**Addendum 3**

Project No: 17017.00

Subject: Wyandotte Central Station Restoration

Date: 10-26-2017

1 Proposed First Floor Plan  
A101 3/16" = 1'-0"

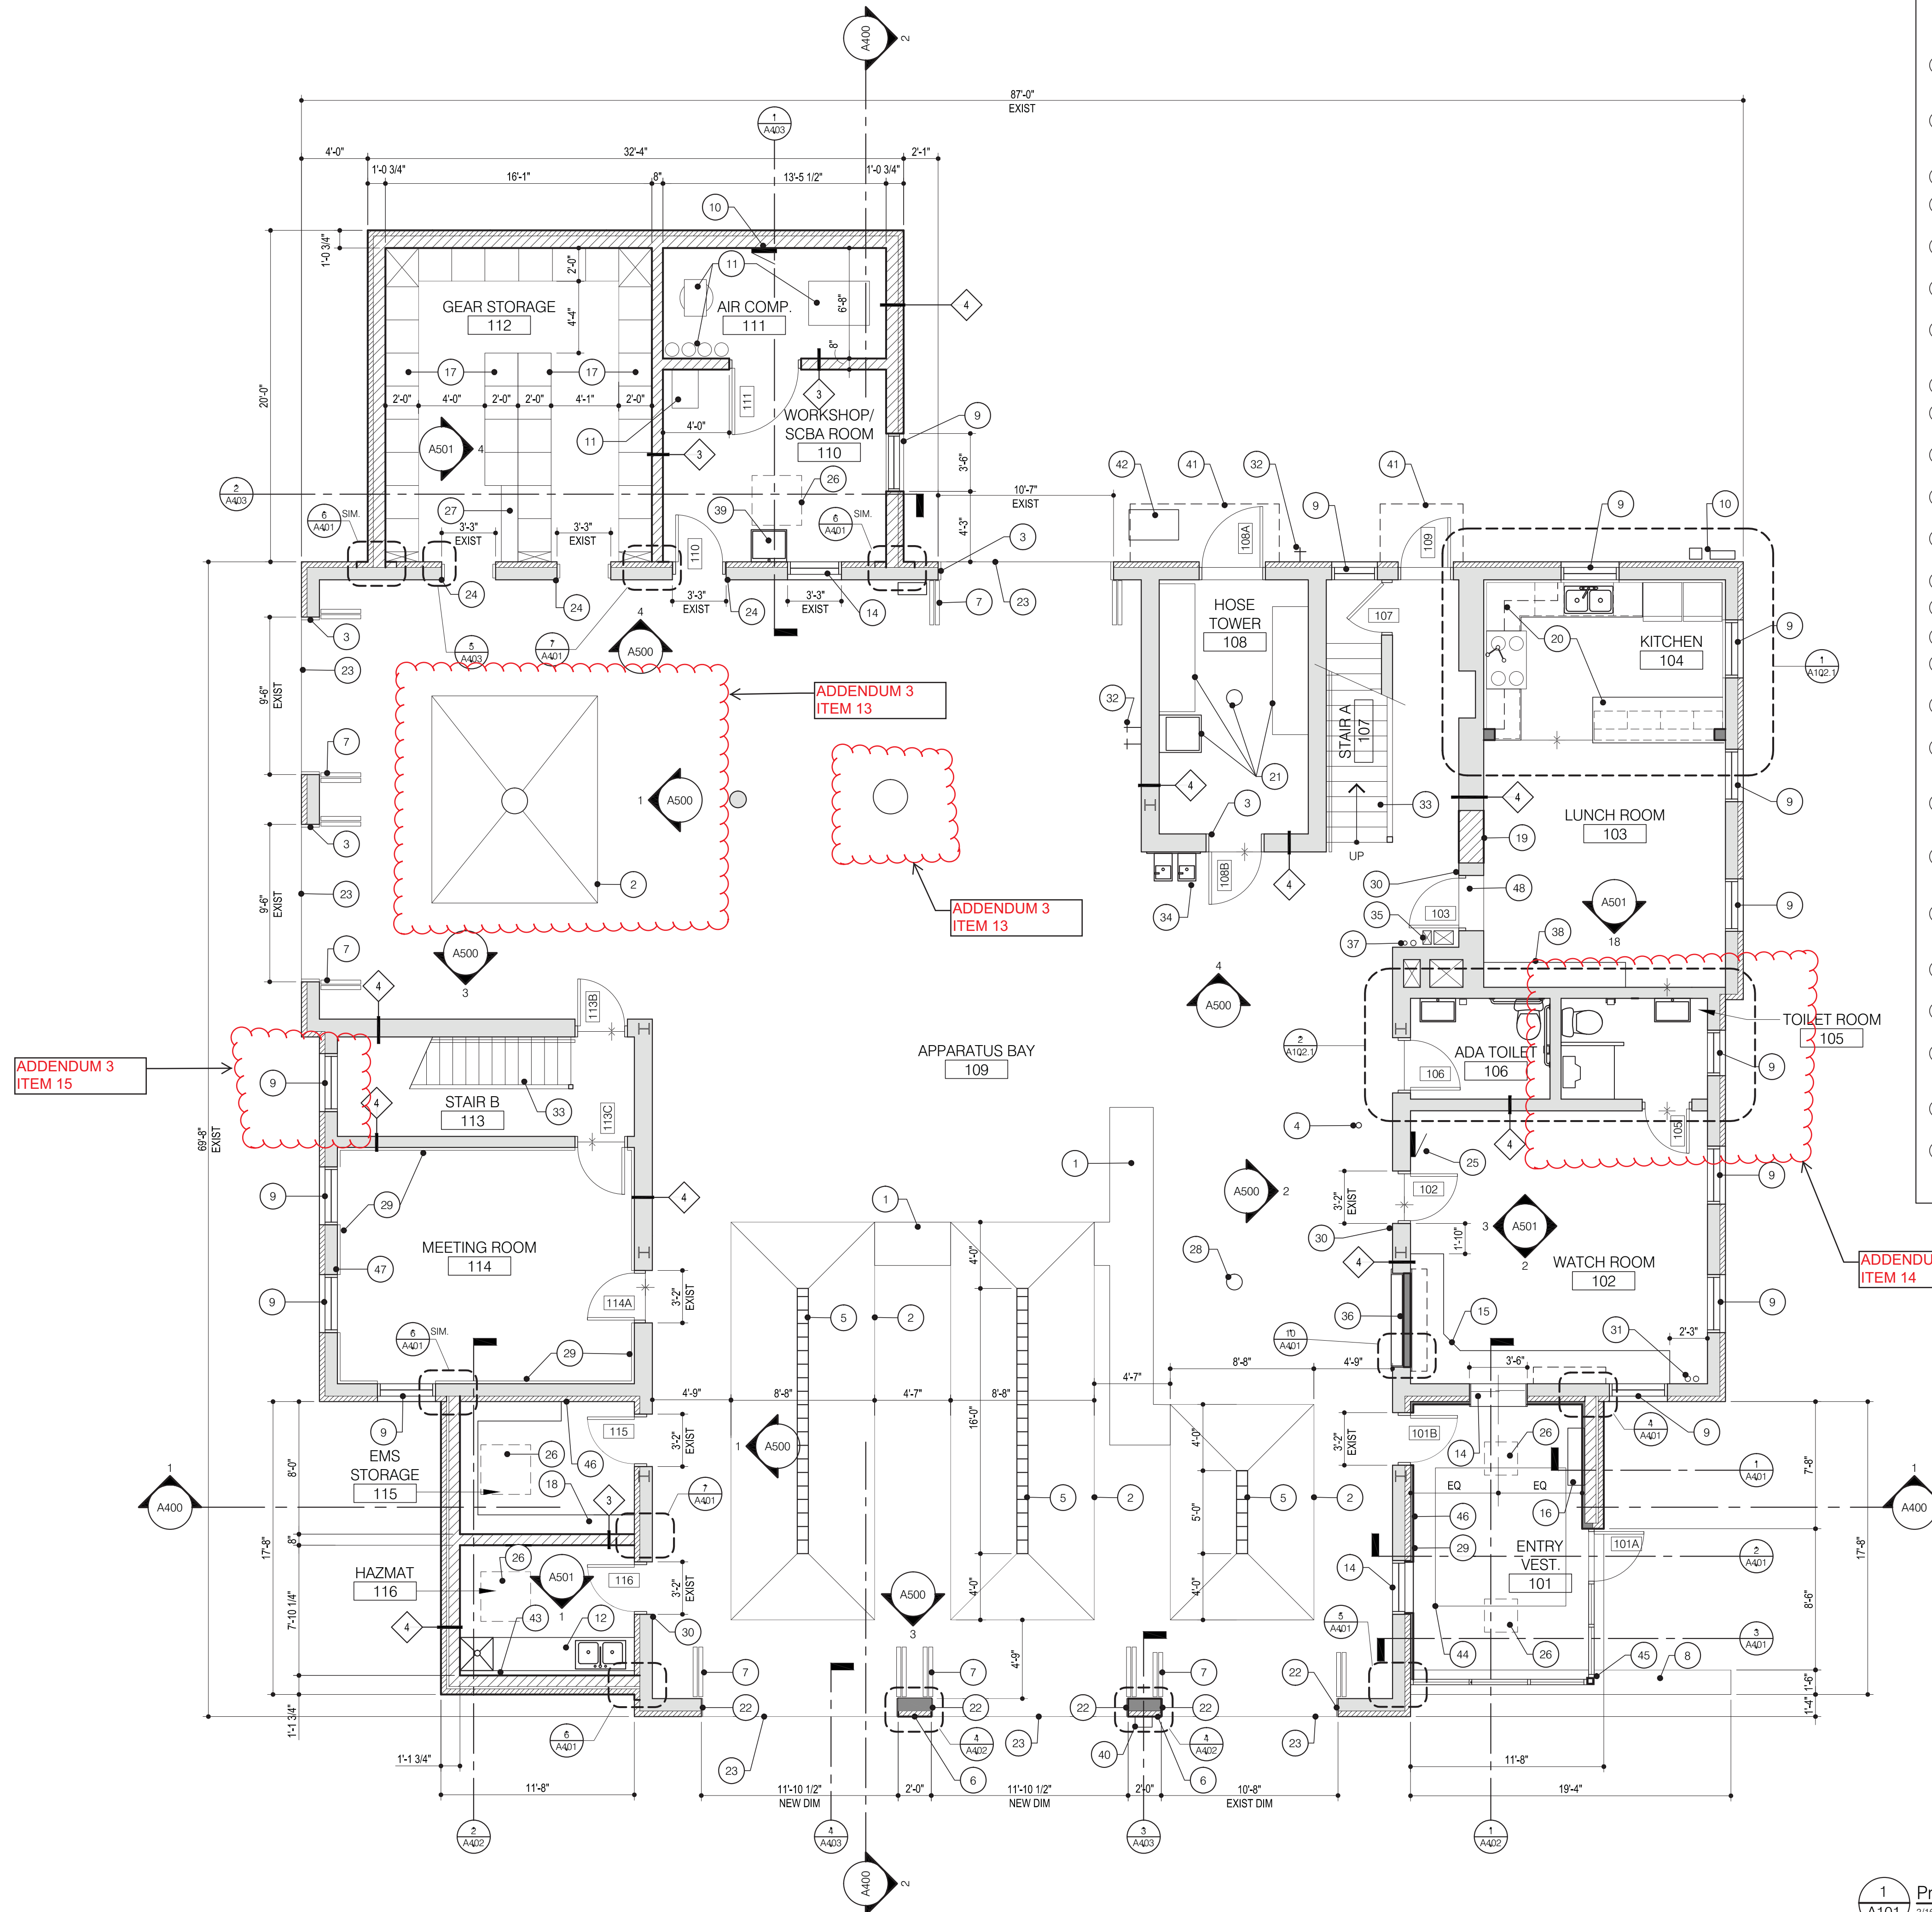
- e. **Bid Alternate 13:** New Floor Drains: (3) of the new trench floor drains called for within the Apparatus Bay 109 are to be eliminated from the project. (2) of the existing floor drains will now remain. (1) of those two existing drains is to be modified as to have the floor slab slope toward the drain. See attached drawing sheets D101 & A101 for revised plan.

- f. **Bid Alternate 14:** Leave first floor bathroom layout, walls, and finishes as-is. Replace the sink and toilet fixtures with new. Existing urinal to remain. Urinal drain to be repaired. Clean masonry walls. Paint walls and ceiling. Existing door frame to remain. Remove existing door leaf and hardware and replace with new door leaf & hardware. See attached drawing sheets D101 & A101 for revised plan.

- g. **Bid Alternate 15:** Eliminate new door 113A from project. Existing window to be replaced with new window in lieu of new door. Elimination of the new door includes the associated exterior wall demo work and new exterior concrete walk/slab. See attached drawing sheets D101 & A101 for revised plan.

1 Proposed Second Floor Plan  
A102 3/16" = 1'-0"

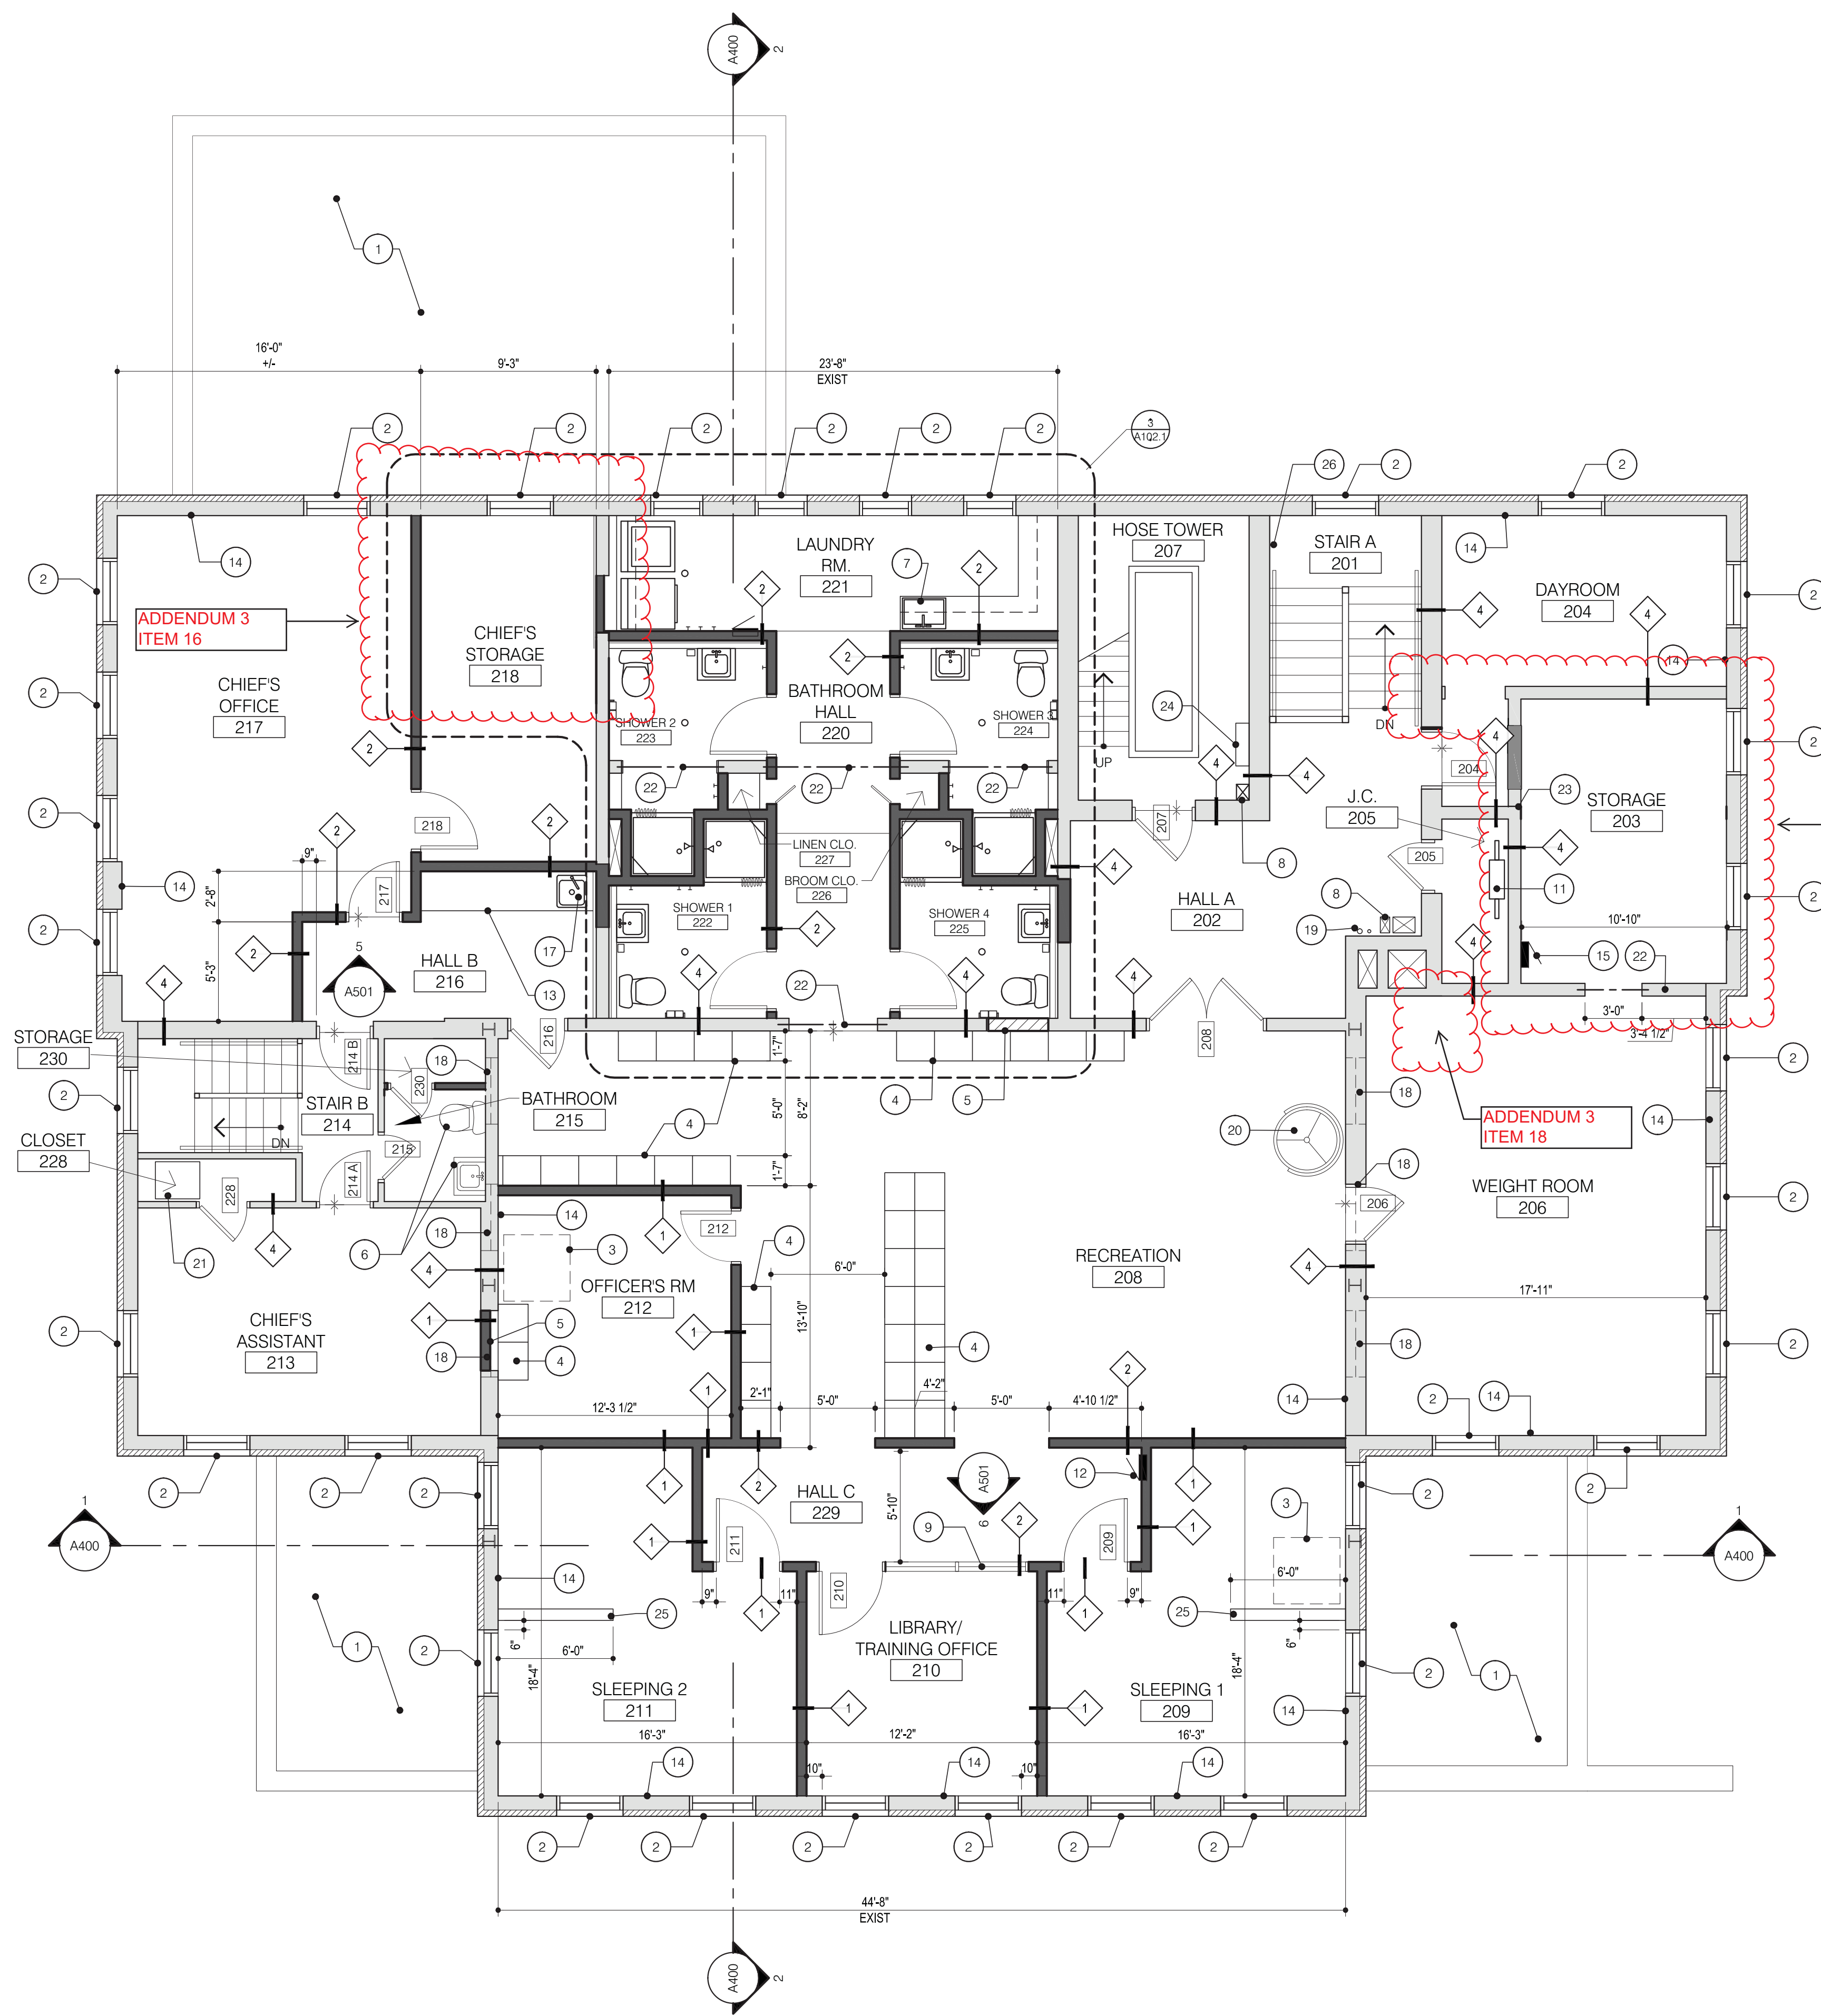
- h. **Bid Alternate 16:** Chief's Bathroom #219 is to be eliminated from the project. See attached drawing sheets D102 & A102 for revised plan.
  - i. **Bid Alternate 17:** Leave the demo walls adjacent to the 2nd floor rooms 'Storage' and 'Private Sleeping' (do not demo/remove). Storage room will still become the 'Day Room #204. Private Sleeping room will still become 'Storage Room #203'. The large wall opening between Storage #203 and Weight Room #206 is to be reduced to a 36" wide opening (which reduces size of lintel). Interior finishes within these rooms remain as indicated on the finish schedules. See attached drawing sheets D102 & A102 for revised plan.

- j. **Bid Alternate 18:** Eliminate new drinking fountain within Weight Room #206. See attached drawing sheet A102 for revised plan.
  - k. **Bid Alternate 19:** Remove new landscaping located at rear (alley facing side) of building. See attached drawing sheet A002 for revised plan.
